COUNTY COUNCIL'S RESPONSE TO CONSULTATION ON THE FOLLOWING DEVELOPMENT PROPOSAL

Application No: 18/00825/HYBRID-3

Proposal: Demolition of buildings and structures as listed in Schedule 1; Outline planning permission for up to 1,175 new dwellings (Class C3); 60 close care dwellings (Class C2/C3); 929 m2 of retail (Class A1); 670 m2 comprising a new medical centre (Class D1); 35,175 m2 of new employment buildings, (comprising up to 6,330 m2 Class B1a, 13,635 m2 B1b/c, 9,250 m2 Class B2, and 5,960 m2 B8); 2.4 ha site for a new school (Class D1); 925 m2 of community use buildings (Class D2); and 515 m2 of indoor sports, if provided on-site (Class D2); 30m in height observation tower with zip-wire with ancillary visitor facilities of up to 100 m2 (Class D1/A1/A3); 1,000 m2 energy facility/infrastructure with a stack height of up to 24m (sui generis); 2,520 m2 additional education facilities (buildings and associated external infrastructure) at Buildings 73, 74 and 583 for education use (Class D1); creation of areas of Open Space, Sports Facilities, Public Park and other green infrastructure; Change of Use of the following buildings and areas: Buildings 357 and 370 for office use (Clas

Fig 1 – Aves Ditch connection

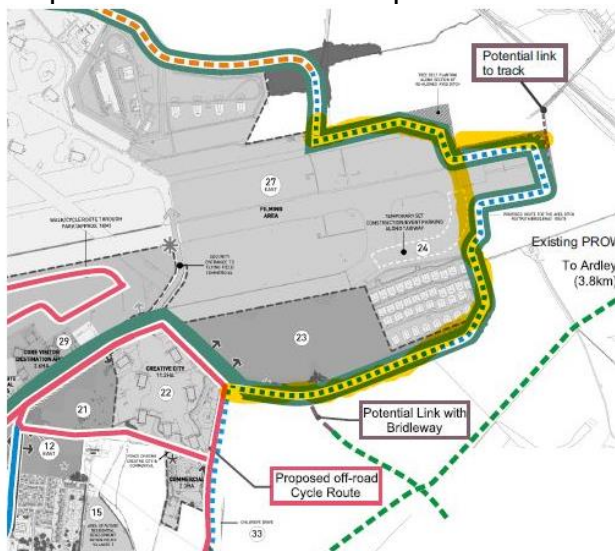
The plan does not show an acceptable route for the connection of Aves Ditch, which is a requirement of the current consent. There has been much discussion of the preferred route, and it is my understanding that the route below has been agreed (shown yellow in Fig 1), which is as per the 2012 agreement in principle, cutting across the 'nib' and including a stub to the Ardley railway bridge connection point. OCC would accept this not crossing the nib, provided the path in fig 3 below is provided, as that will provide PRoW users' experience of crossing the runway.

Fig 2: Walking link from Parcel 23 to Flying Field Park

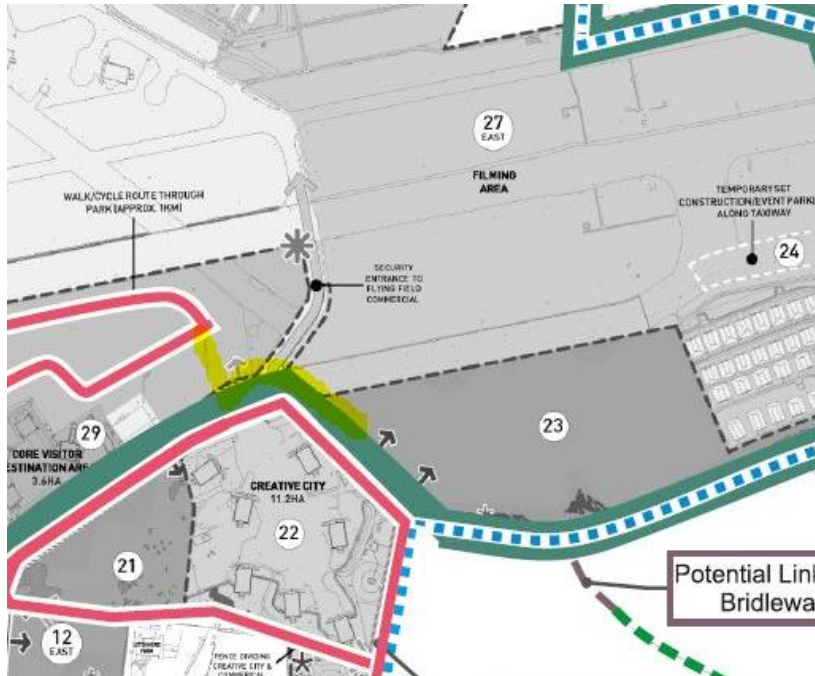
There should also be an additional walking link from Parcel 23 to Flying Field Park, shown yellow in Fig 2. This will benefit residents of parcel 23 and other Heyford Park residents and visitors.

Fig 3

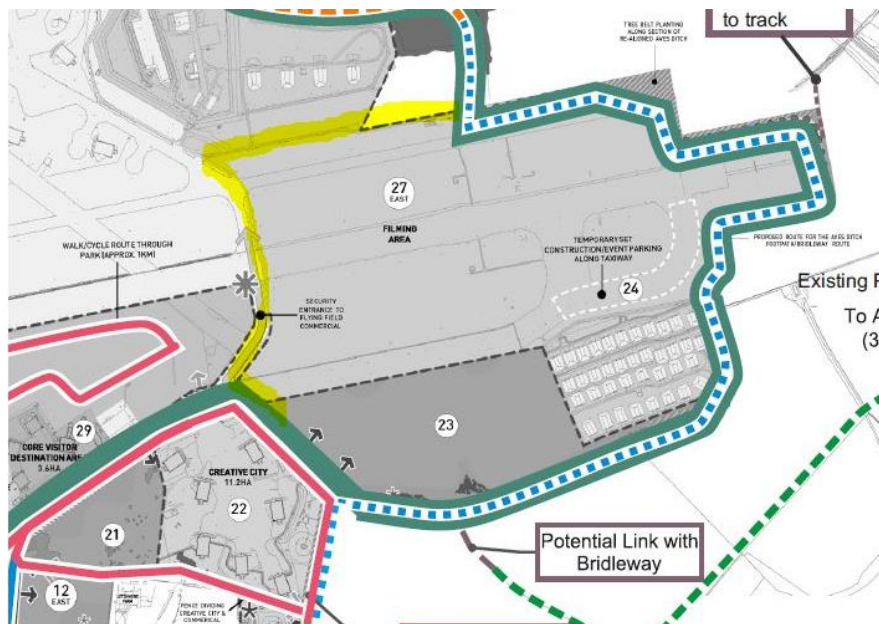
There should also be an internal walk and cycle route (no need to be a bridleway) north of parcel 23 across the runway and then east to connect with Aves Ditch connection, as shown yellow in Fig 3. This will also benefit residents of parcel 23 and other Heyford Park residents and visitors.

- **Shape of school site**

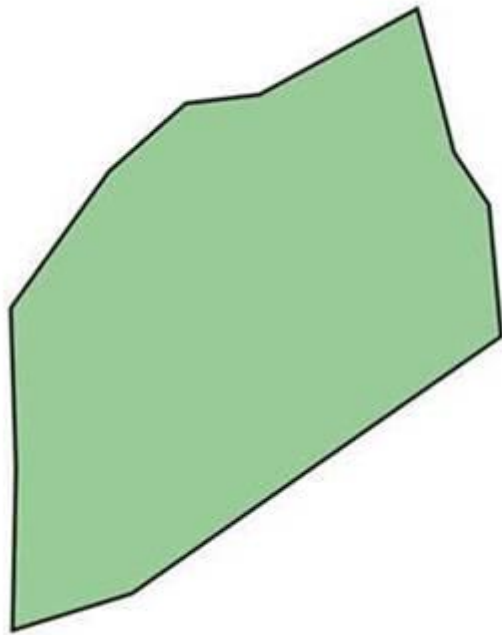
It has not been demonstrated that the proposed shape of the school site is conducive to the creation of an economic laying out for the school or to provide the minimum external play areas requirements. The current shape doesn't appear to fit the basic OCC playing field requirements without further compromising the other areas of the site.

A distorted playing fields provision would not be accepted with its potential to compromising the delivery of a team games playing field to meet curriculum requirements.

The problems with the distorted shape of the site is obviously exacerbated by the proposal to keep a hanger on the site, which effectively sterilises a large area of the school site.

The scheme design boundary shown on **design update May 2020 REVA** doesn't match the boundary within the application

- a) English Heritage/District to accept the realignment of the boundary to ensure a playing field could be provided
